Office Action Summary	Application No. 10/701,883	Applicant(s) MUHANNA ET AL.	
	Examiner CHRISTOPHER D. PRONE	Art Unit 3738

DETAILED ACTION

Claim 1, 2, 4, 6-10, 15, 18, 20, and 50-52 is rejected under 35 U.S.C. 103 as being unpatentable over Michelson United States Patent 6,890,355 in view of Brantigan United States Patent 5,192,327 and Viart et al United States Patent 6,682,562 B2.

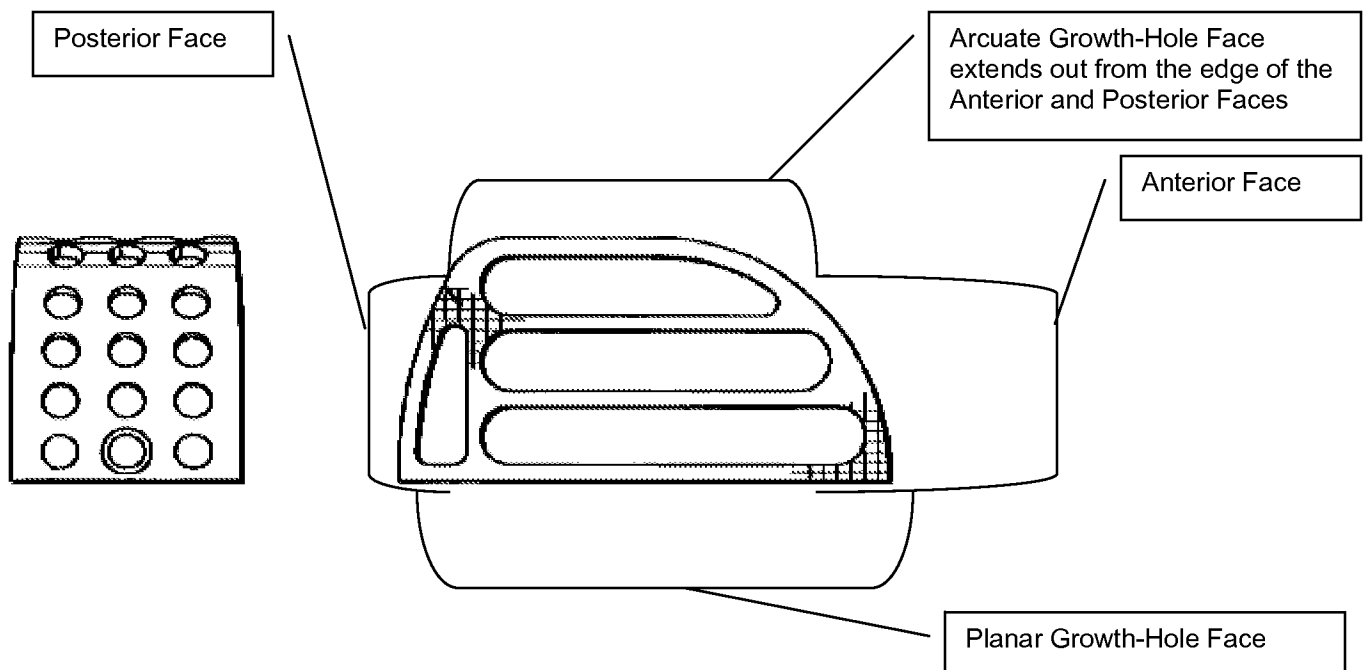
Michelson discloses a metal vertebral body replacement comprising a body 300, nonparallel top and bottom surfaces (shown best in figures 15-17) having a plurality of through holes and continuous grooves 314 and protrusions (5:62-65), two growth hole faces 310 (planar) and 312 (curved) having 4 through holes 319 and a curves anterior face 304. Michelson further discloses use of a second identical implant for insertion along side the first 300".

In response to the amended language a marked up figure is included below to demonstrate how the arcuate growth-hole face extends outward.

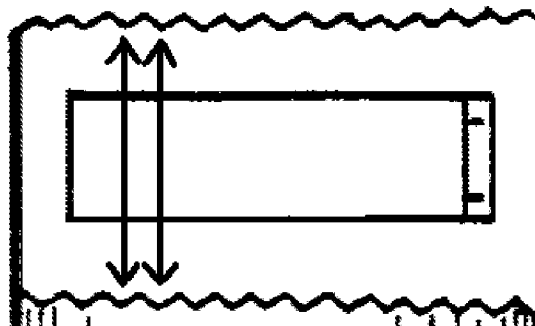
Brantigan discloses a spinal implant comprising a body having a top surface with projections and grooves that extend generally along the top through the anterior and posterior faces wherein the projections and grooves are unaligned (see figure below) in the same field of endeavor for the purpose of securing the implant to the implant site.

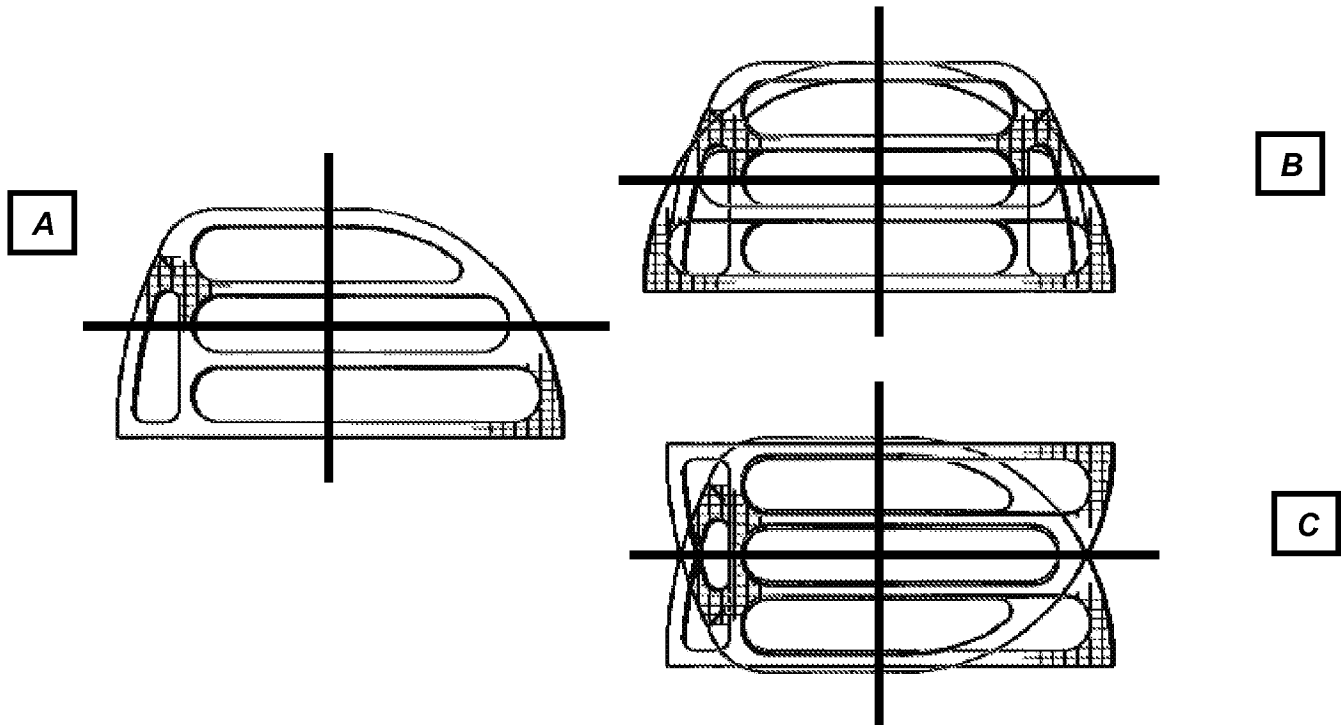
Applicant's arguments filed 12/23/09 have been fully considered but they are not persuasive. The applicant argues that Michelson fails to disclose an arcuate growth-hole face extending outward. This is not persuasive and has been addressed in the figure included above. The applicant further argues that Michelson fails to disclose serrations and at least one elongated groove in the top of the body that extends through the anterior face and the posterior face of the body in which teeth forming the serrations providing openings generally orthogonal to the at least one elongated groove. This is not persuasive because the combination relies on the teachings of Brantigan disclosing the use of grooves that extend through the anterior and posterior faces and Viart disclosing making the serrations out of a plurality of separate teeth to

read on this claim language. The applicant further argues that implant is not asymmetrical when viewed from above. The following figure is included to show that the implant of Michelson is asymmetrical when viewed from the top. Figure A is the original top view of the implant. Figure B includes a top view of the implant that has been flipped horizontally and superimposed over the original top view. Figure C includes a top view of the implant that has been flipped vertically and superimposed over the original top view.
